Cadia Continued Operations Project (SSD-71290981) – Notification of amendments to the project design and associated disturbance area

FIGURE 1

Cadia Continued Operations Project - Refinements

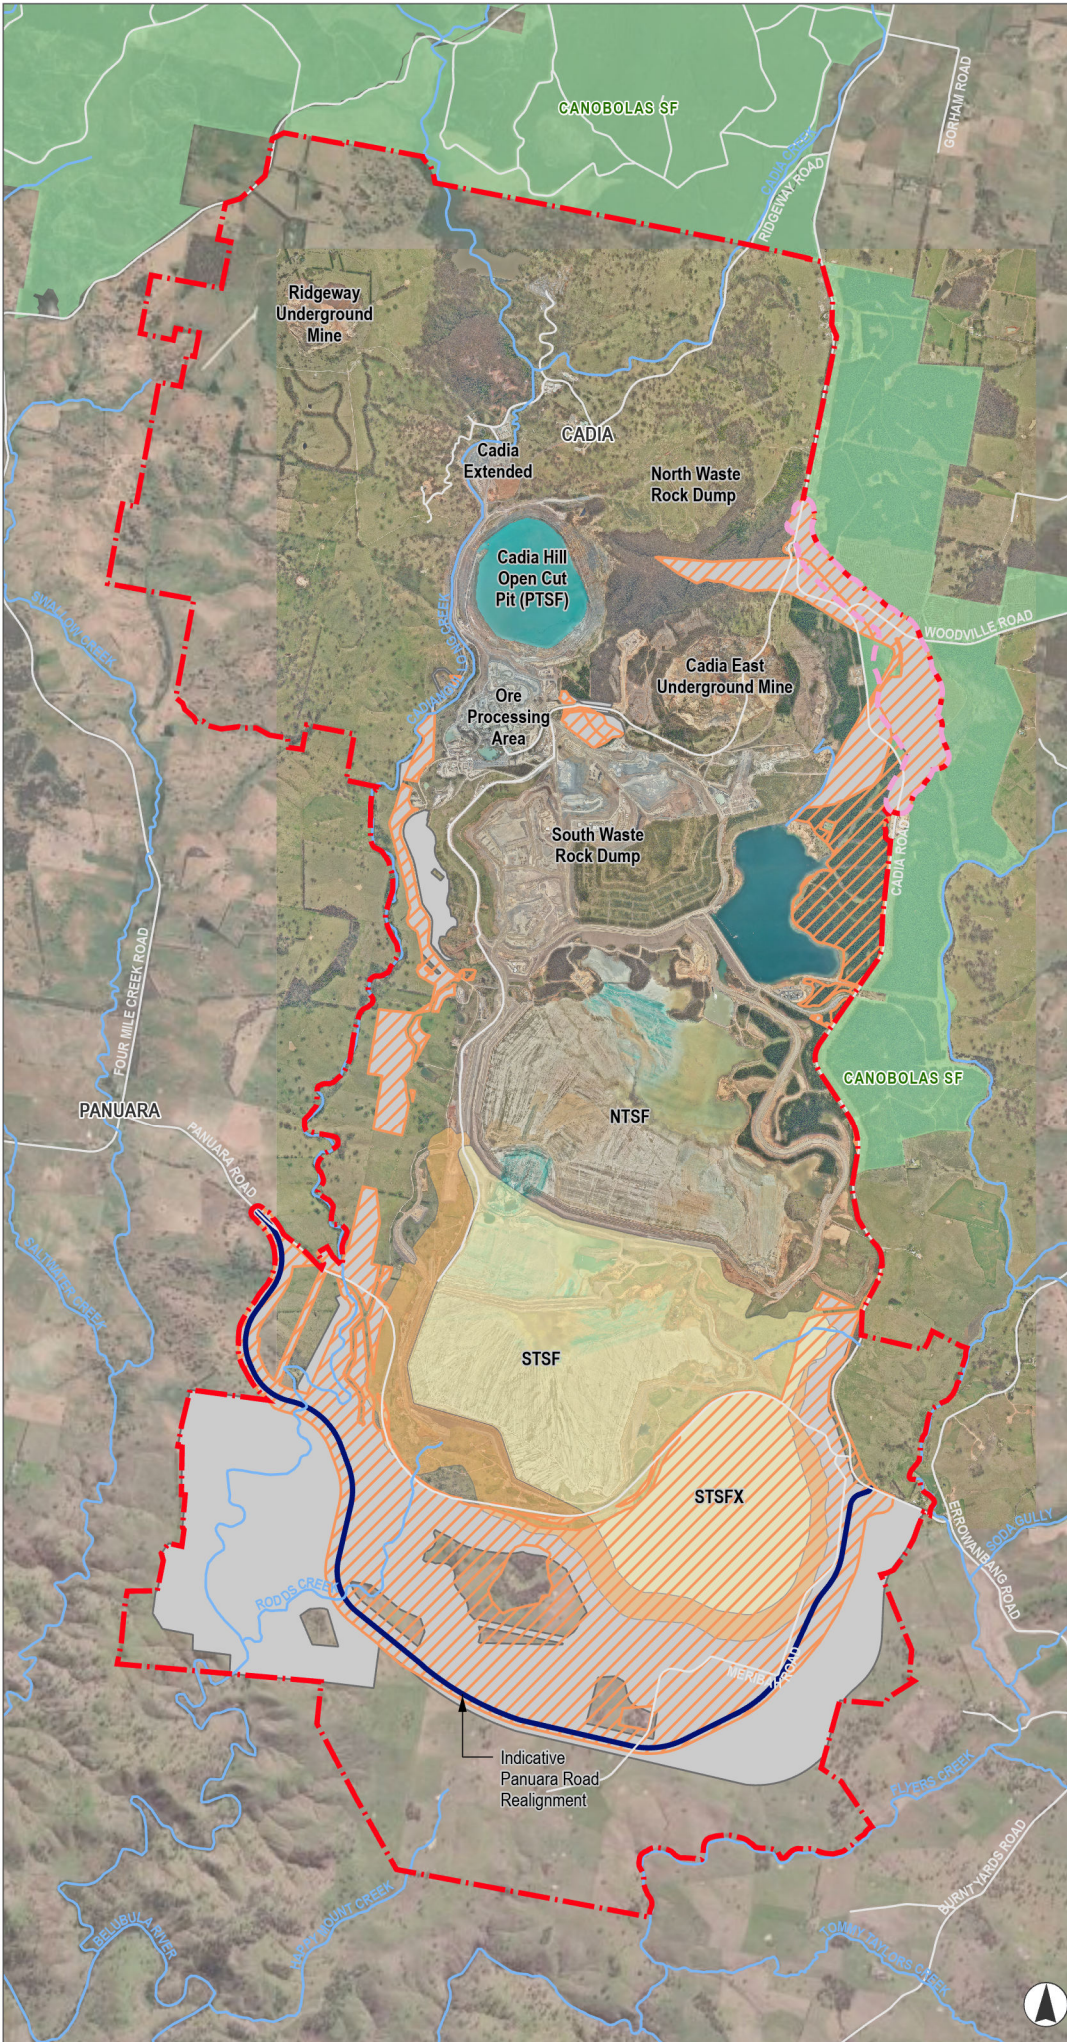
- the removal of the South Water Storage (SWS); and
- minor refinements to infrastructure layouts and the associated disturbance area for CCOP.

Following further technical assessments and community consultation, the SWS was removed from the CCOP and is no longer proposed. The removal of SWS from the CCOP:

- avoids disturbance area impacts to Cadiangullong Creek, including impacts relating to water, biodiversity, heritage and agricultural; and
- avoids amenity impacts from the construction of the SWS, such as noise blasting and visual impacts at nearby landholders to the south-west.

Since the Scoping Report was submitted in May 2024, Cadia has continued to progress the detailed design of the CCOP and has identified opportunities to further refine the designs associated with the Panuara Road realignment and the STSFX and associated infrastructure.

These changes have resulted from the incorporation of community feedback into these project elements and necessitate a refinement (and reduction) in the proposed disturbance area.

The change in additional disturbance associated with the CCOP from Scoping Report to current as proposed is shown in **Figure 1**.
